**FRIENDS
OF THE
RIVER**

April 29, 2005

Re: Comments on Battle Creek Restoration Project SEIS/REIR

Battle Creek SNTMP
MOU, Alt B , Unimpaired Temperatures
Dry and Warm Extreme Condition
Daily Average Water Temperature Profile in August

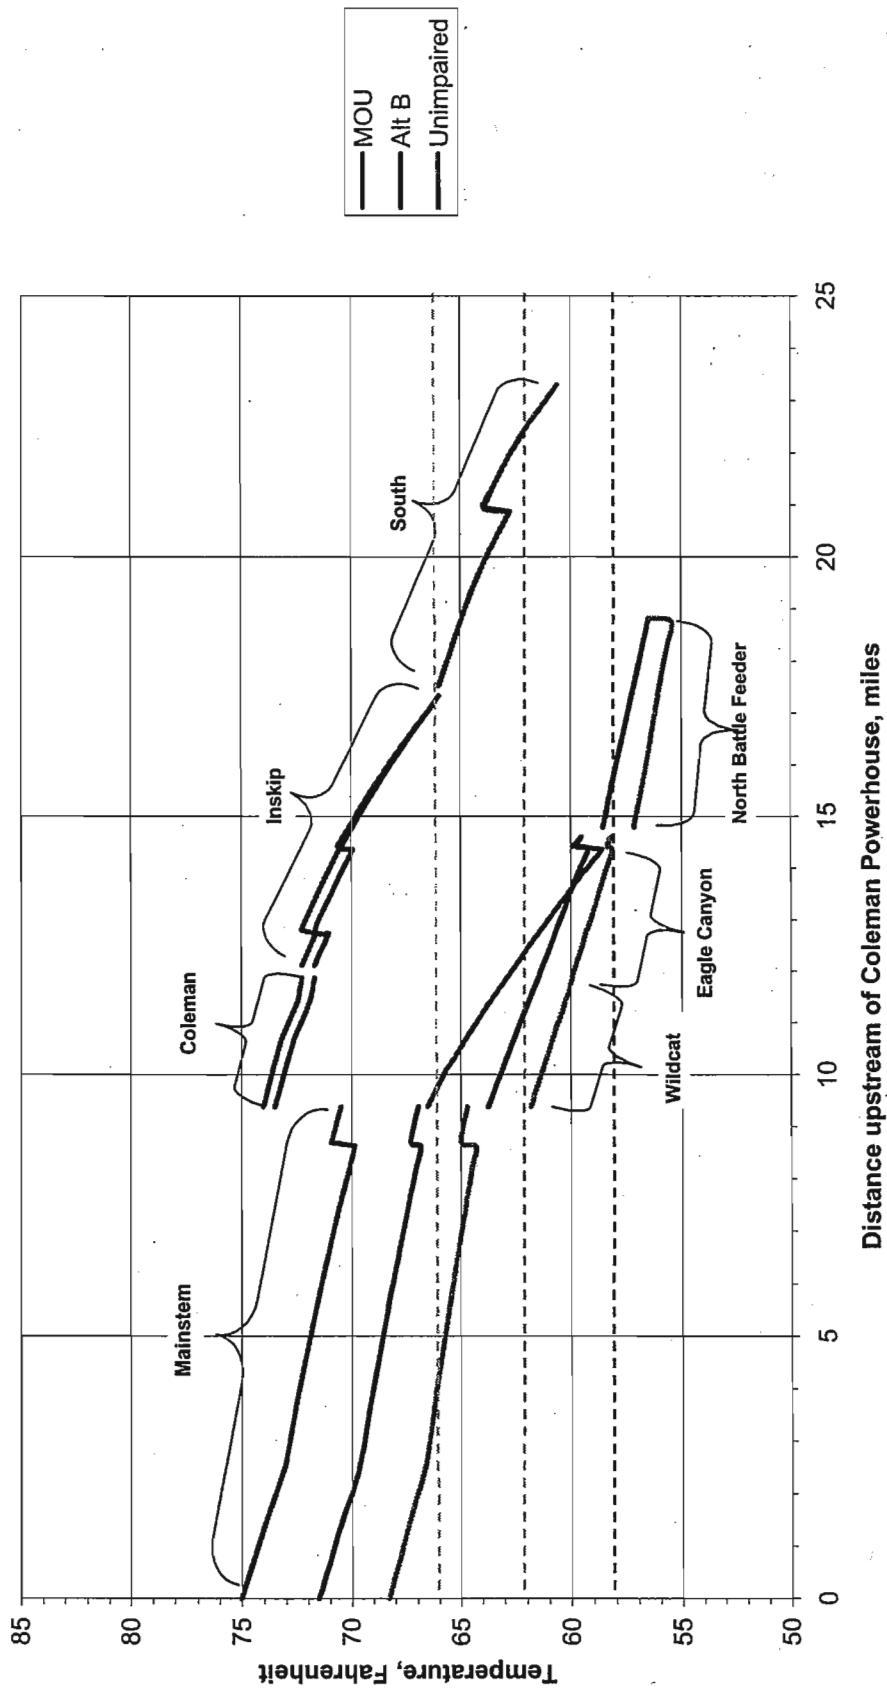
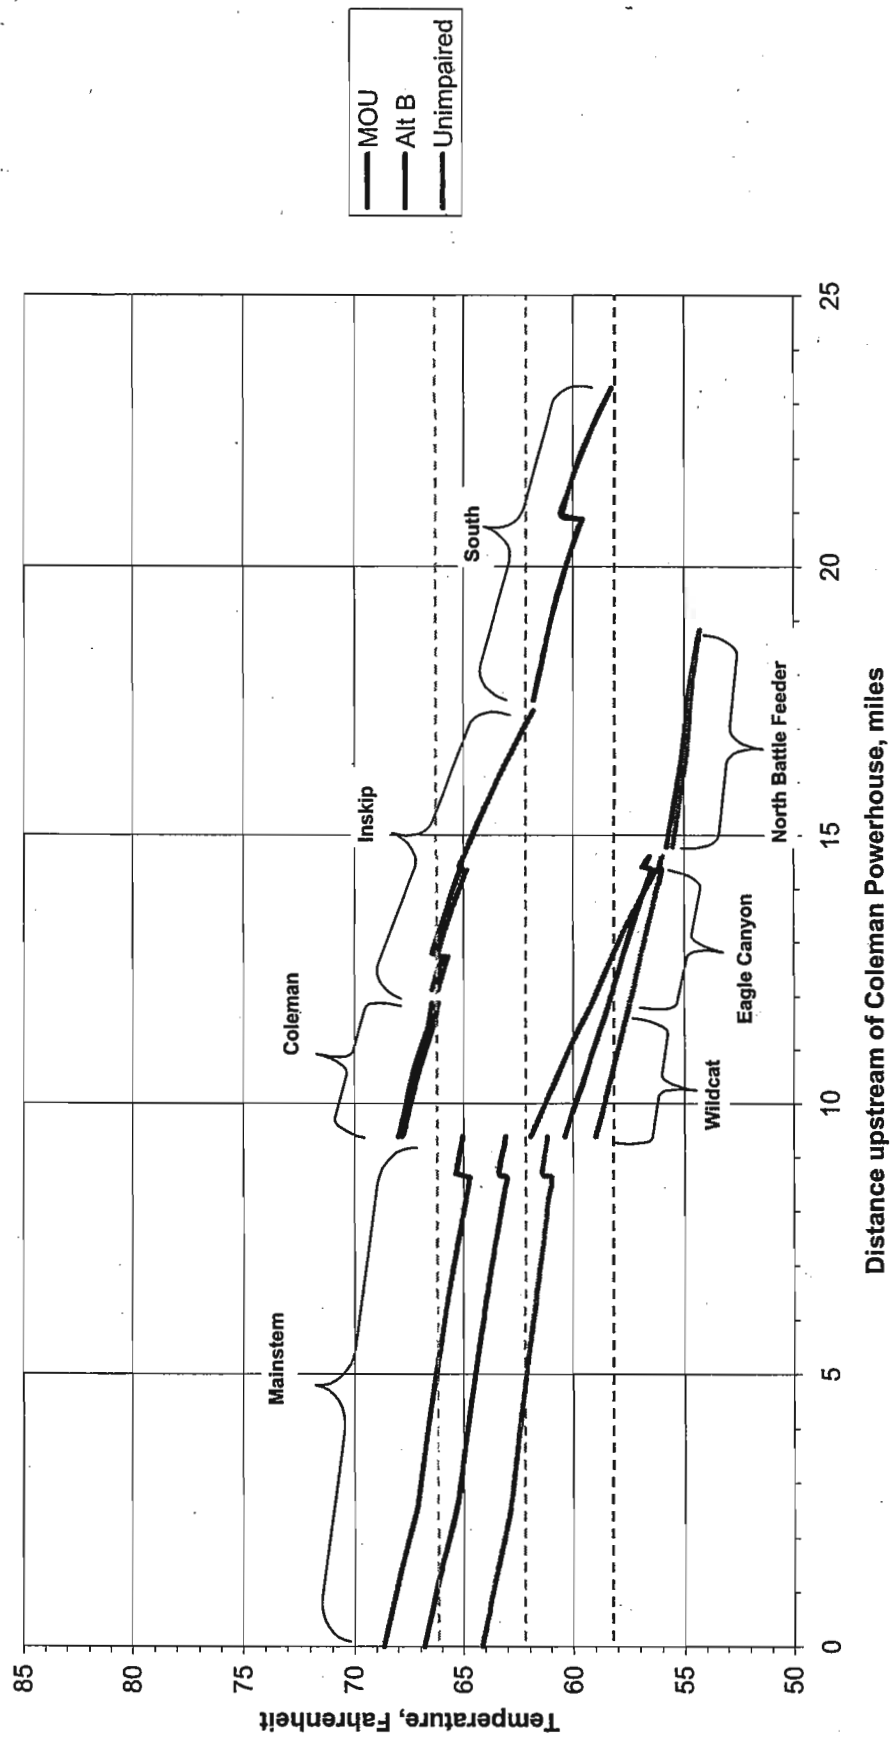
Figures T-1 to T-8 show that Alternative B is predicted to provide cooler water than the MOU in the North Fork, South Fork, and mainstem Battle Creek in all months, for both normal and warm/dry years. Various life stages of four races of chinook salmon and steelhead utilize Battle Creek each month of the year. Assuming temperature thresholds of 66°F for juveniles, 62°F for prespawning adults, and 58°F for incubating eggs (Armour, 1991), in an average June, Alternative B provides an additional 8.7 miles of rearing habitat in the mainstem and South Fork, and an additional 2.5 miles of adult holding habitat in the forks of Battle Creek. In September, Alternative B provides an additional 8.5 miles of adult holding habitat in the mainstem and South Fork Battle Creek and 1.3 miles of egg incubating habitat in the North Fork.

These results are conservative. As described in detail in the following paragraphs, limitations presented by the "hybrid" approach to modeling Alt B, and the flow assumptions of SNTEMP itself combine to significantly understate the temperature benefits of the 8 dam removal alternative. Corrected, SNTEMP would show even greater temperature benefits to Alternative B.
